FIELD SERVICE NEWS

NO. FAN-032

FA-200 ADDITION OF PLATE FOR BATTERY INSTALLATION

FIGURE 1. PLATE (LOCALLY FABRICATED)

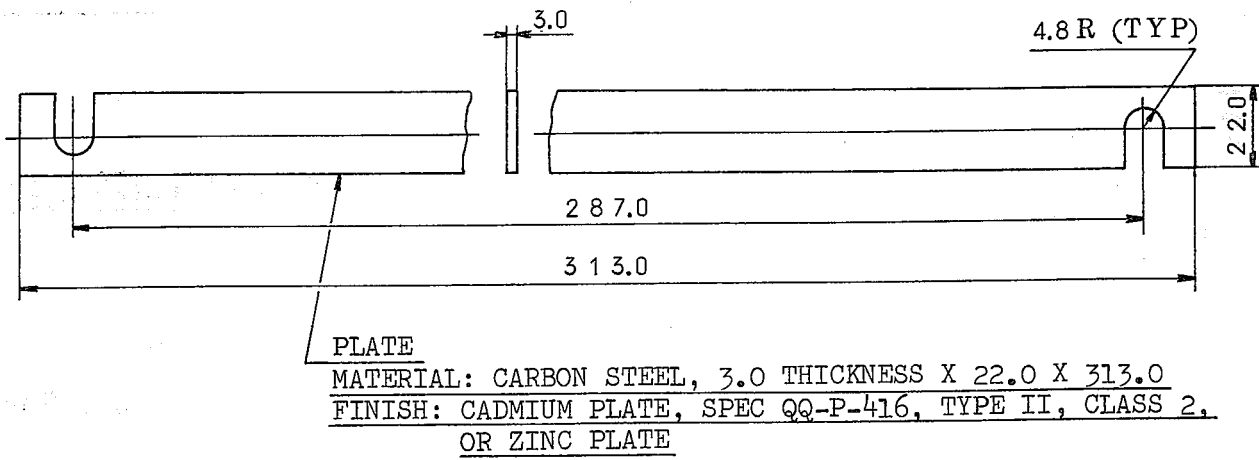
There have been instances reported whereby the plastic case of the battery P/N 200-383602-001, used on FA-200 airplane, has been cracked due to over-tightening of the clamp. If the battery is installed properly by adjusting length of the rods, battery installation is designed to sufficiently withstand cracks or other damages. To accomplish proper installation, it is necessary to adjust the rod length properly to fit the battery case. Your battery will be free from requirement of precise rod length adjustment if a plate is installed as shown in the attached figure.

It is therefore recommended that a plate be locally fabricated to dimension shown and added between the plastic case and clamps as illustrated in the figure 2.
